TOWNSHIP OF ABINGTON

(2) CODE ENFORCEMENT AND LAND DEVELOPMENT COMMITTEE

**CE1. Subdivision SD-16-07 – Robert Morris – 1511 Susquehanna Road
and 1112 Rydal Road**

Re: Staff Review Comments on Application SD-16-07 for the property located at 1511 Susquehanna Road, Rydal, Pa. 19046

ABINGTON	Montgomery	6-22-16	1"=40'
Project No.	H2244	Project Name	SKETCH.DWG
Sheet No.	3 of 4	Scale	
Revision No.	1	Date	9-1-16
Description	PER TOWNSHIP REVIEW COMMENTS	Drawn By	JCB
Checked By		Reviewed By	JCB/VTR

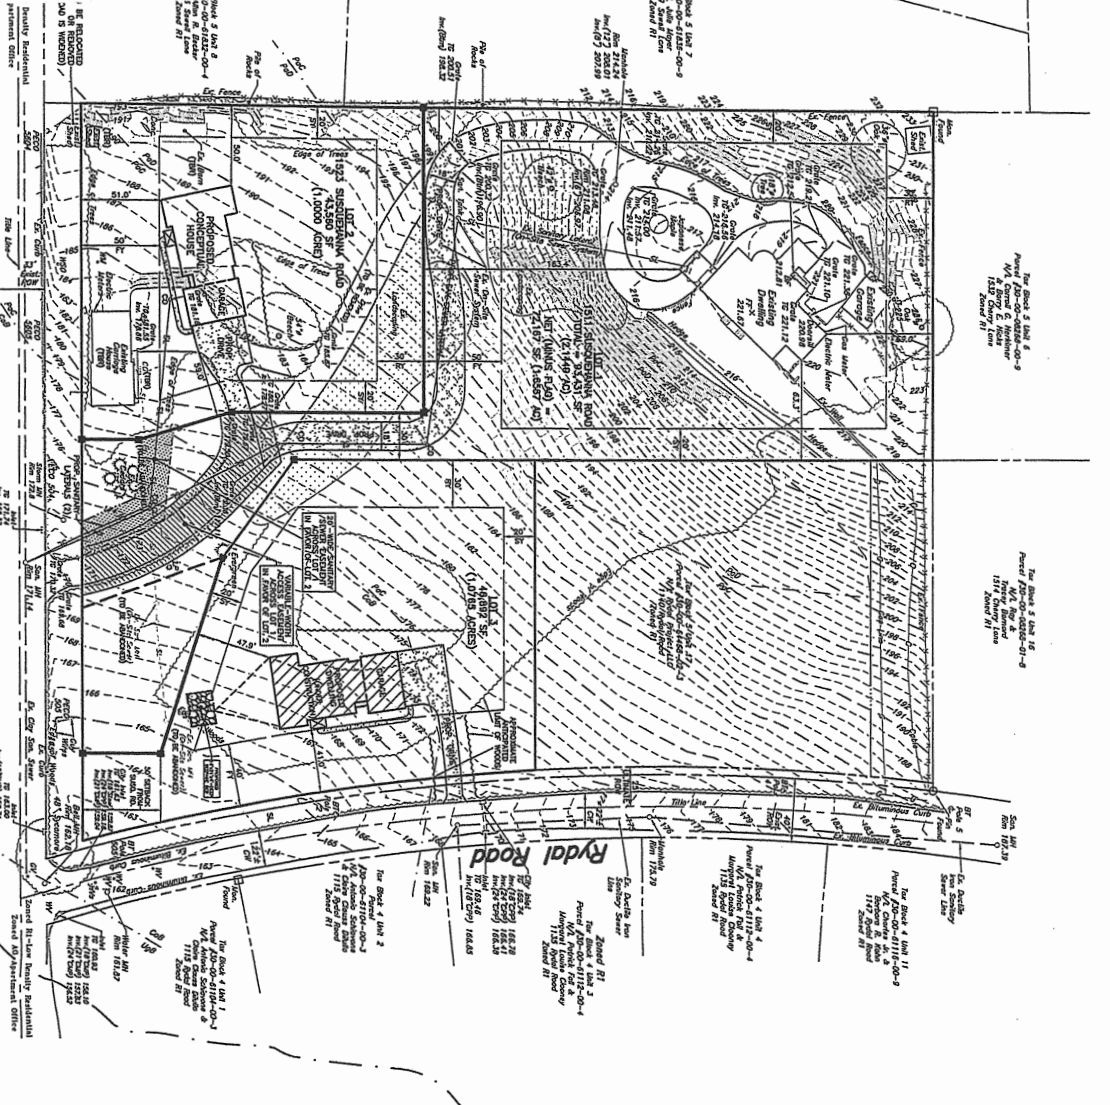
6. The driveway to serve Lot #1 proposes changes to the cart way that indicate a narrow driveway with turns that exceed 90 degrees. This office is requesting a revised driveway plan that will better allow access to the single family dwelling located on Lot #1.

13. With regards to the sanitary laterals for both Lots #1 and #2, the plans indicate them being connected into a manhole in Susquehanna Rd. We would rather see a 6" pipe extended from the existing manhole and a new manhole positioned off the cart-way, near the ROW line, and then both laterals connected to it.

16. The plans indicate a gas line and communication line crossing the top-right property (which is labeled incorrectly) for Proposed Lot #1. An easement will have to be created and filed with the deeds for both properties.

17. The property above "Lot 3" is identified incorrectly. The correct parcel number is 30-00-64468-02-3 and is addressed as 1140 Rydal Ave.
18. The "FEMA 100 Year Floodplain" line has changed as of March 2, 2016. The applicant should make the change on these plans.

19. The plans indicate many grates around the existing dwelling on Prop Lot 1. We would like to know where these storm pipes (assumedly) extend and discharge. We cannot allow storm lines to traverse another property without their knowledge or without ROW.

26. Engineering Comment #18 states that the limits of the 100 year flood plain have been revised. The plan needs to reflect this change and the review of this application cannot be completed until the location of flood plain has been plotted.

27. Tree protection measures need to be shown for the 54 inch Beech tree plotted on Lot #2. The tree protection detail shown on sheet #4 will not work for this tree. The proposed single family dwelling is plotted as being as much as 10 feet within the drip line of the Beech tree.

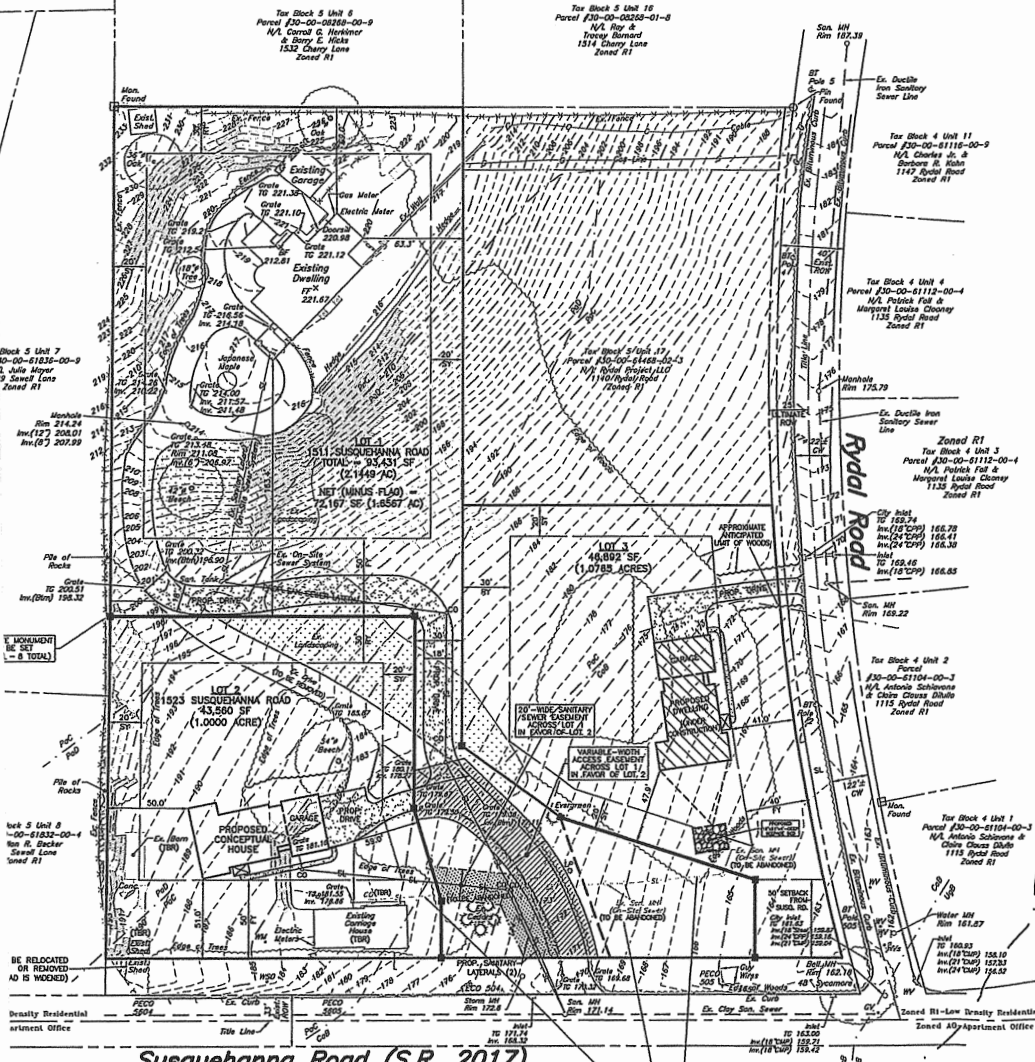
-  A. The proposed building and driveway would protrude into the drip line of the 54" beech tree under the proposed plan, and as a result that tree would not survive. We recommend the applicant modify the plan to preserve the tree, consistent with the provision that the subdivider endeavor to preserve existing shade trees [§146-39].
